Urban Design Consultation

Applications
24/02305/FUL - Proposal Full planning application for the conversion of existing buildings to provide four dwellinghouses including demolition and extension to existing buildings.
24/02292/FUL – Conversion of existing buildings (including removal of lean-to structure and extension) to provide residential annexe.
Location – Agricultural Buildings, Manor Darm, Thurning Road, Winwick
Case officer – Hannah Hodges Charlotte Dew

These comments are provided on the submitted amended plans and response to UD officer comments document 21.07.25. New comments in green below.

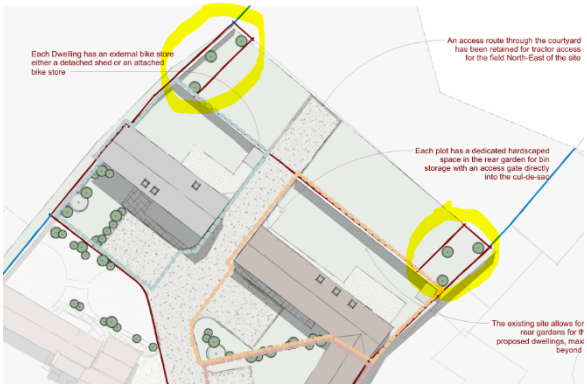
Both The Long Barn and The Granary have projecting rectangular areas of curtilage (highlighted in yellow below) beyond their associated private amenity space. It is unclear what these spaces will be used for or why they extend into the blue land. Further information is required and it is recommended that these rectangular shaped pieces of land be omitted. Previous comments have not been addressed. It is understood from the response to UD officer comments that these two areas are included for BNG.

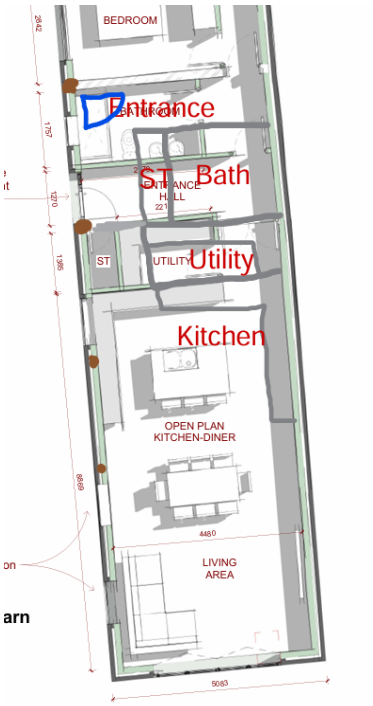
The Goose Barn (building C) – this is currently a 6 bay open fronted cart shed with brick store either end. The 6 bays are divided by timber vertical posts. Note this building will require significant repair / rebuilding. The proposal fills in the open bays and it is not clear how the vertical timber posts will be incorporated. To retain the open fronted character of the building the following is recommended:

- New wall / glazing be set behind the frontage timber posts so that the original bay division is fully visible (See examples below).

Bay division retained with timber posts and glazing – condition required to show exact location of glazing and size of timber posts. To be conditioned.

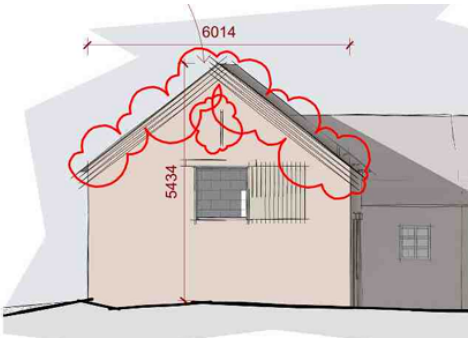
- Question if bed 1 (at western end) requires 3 windows, recommend retain gable window with one additional either to north or south. Updated with retained window to the west and new window to the north.
- Western gable feature arrow slit window, hayloft opening (within the gable apex) and decorative brick verge to be retained.

Amended elevation illustrates retained arrow slit and decorative brick verge. Also shows window, however proportions do not appear to align with photo –roof pitch appears too shallow on the plan, retained window on photo is within the apex. Plan updated.
